Z-36  
(2015)

REZONING PLAN  
2400 HURT ROAD

# Z-36

**ZONING COMMENTS:**

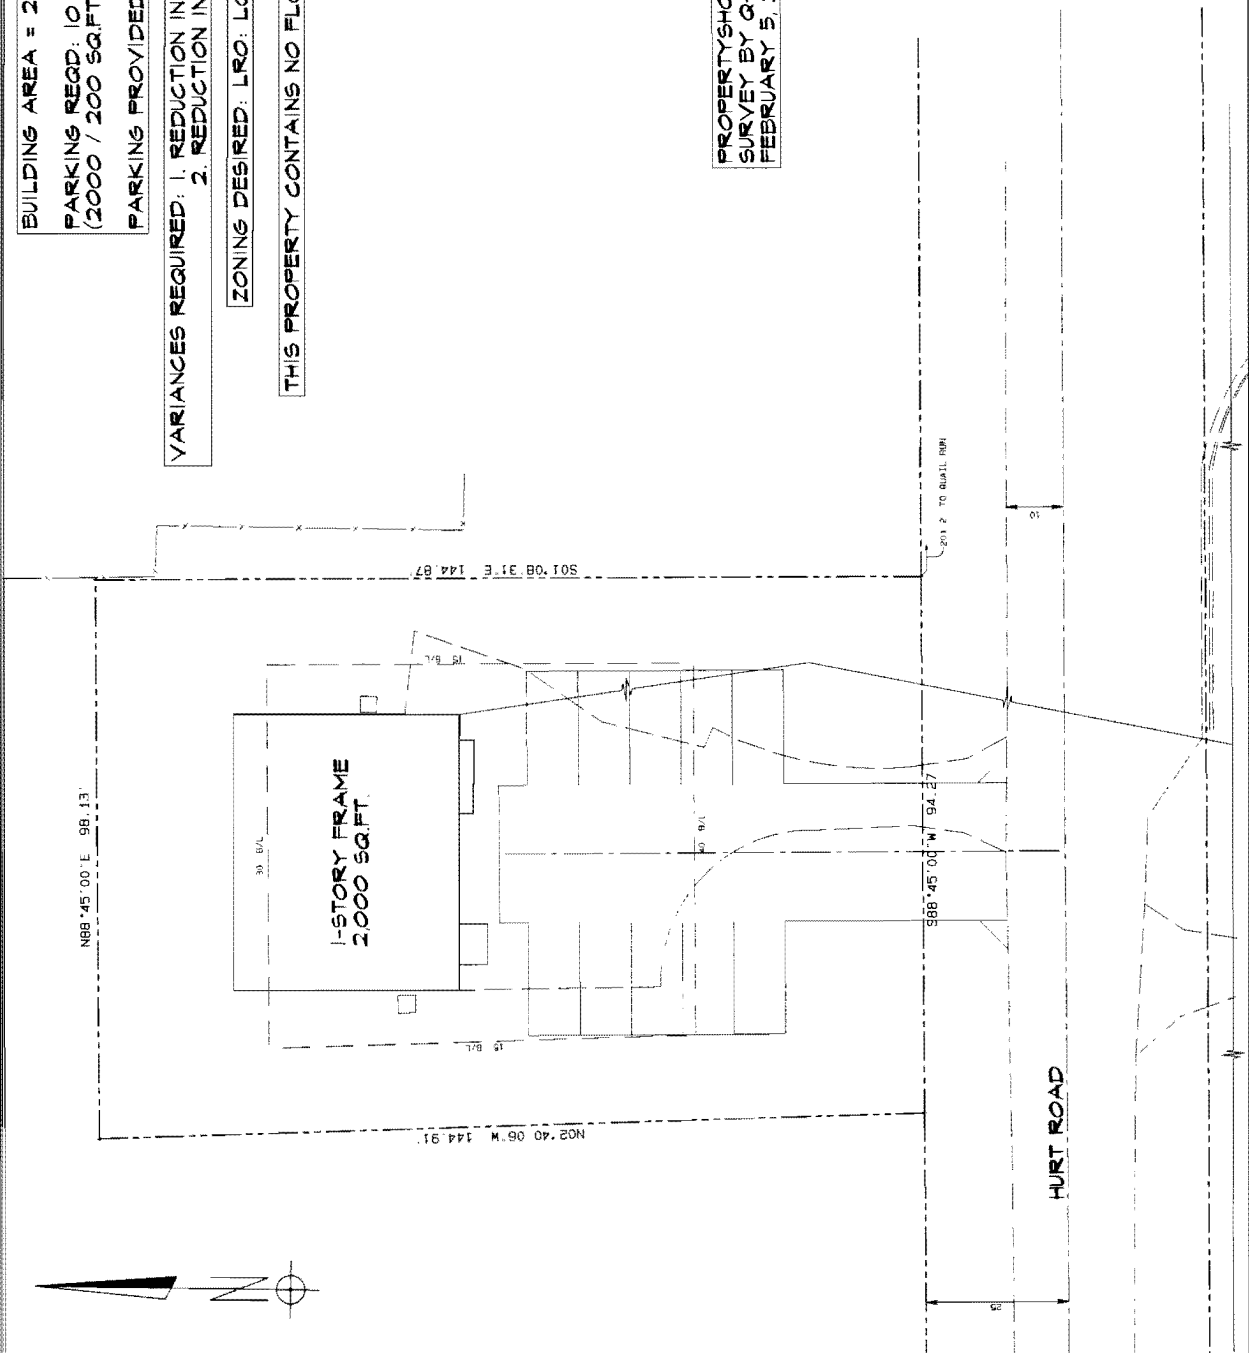
The applicant is requesting contemporaneous variances to reduce the minimum lot size from 20,000 square feet to 13,936, waive the rear setback from 30 feet to 22 feet, and to reduce the landscape buffer from 20 feet to 10 feet.

1. The site is located to the north of Hurt Road. The entire site drains to the south to the Hurt Road R/W.
2. The applicant is proposing to use the existing structure with no significant site improvements anticipated. Full stormwater management must be provided upon redevelopment or substantial improvement of the site.

Hurt Road is classified as a major collector and according to the available information the existing right-of-way does not meet the minimum requirements for this classification.

Recommend applicant verify that minimum right-of-way is available for Hurt Road and if it is not, recommend applicant consider entering into a development agreement pursuant to O.C.G.A. 36-71-13 for dedication of the following system improvements to mitigate traffic concerns: a) donation of right-of-way on the north side of Hurt Road, a minimum of 40' from the roadway centerline.

Recommend the driveway be upgraded to the commercial standard.

Recommend curb, gutter and sidewalk for Hurt Road at the time of redevelopment.

Recommend taper for the Hurt Road access at the time of redevelopment.

- Site plan received February 6, 2015;
- Professional office use only;
- No outdoor storage;
- Applicant install a 10 foot landscape buffer adjacent to the north, west, and east property lines to be approved by the County Arborist;
- Fire Department comments and recommendations;
- Water and Sewer comments and recommendations;
- Storm water Management comments and recommendations;
- Department of Transportation comments and recommendations;
- Owner/developer to enter into a Development Agreement pursuant to O.C.G.A. §36-71-13 for dedication of system improvements to mitigate traffic concerns.
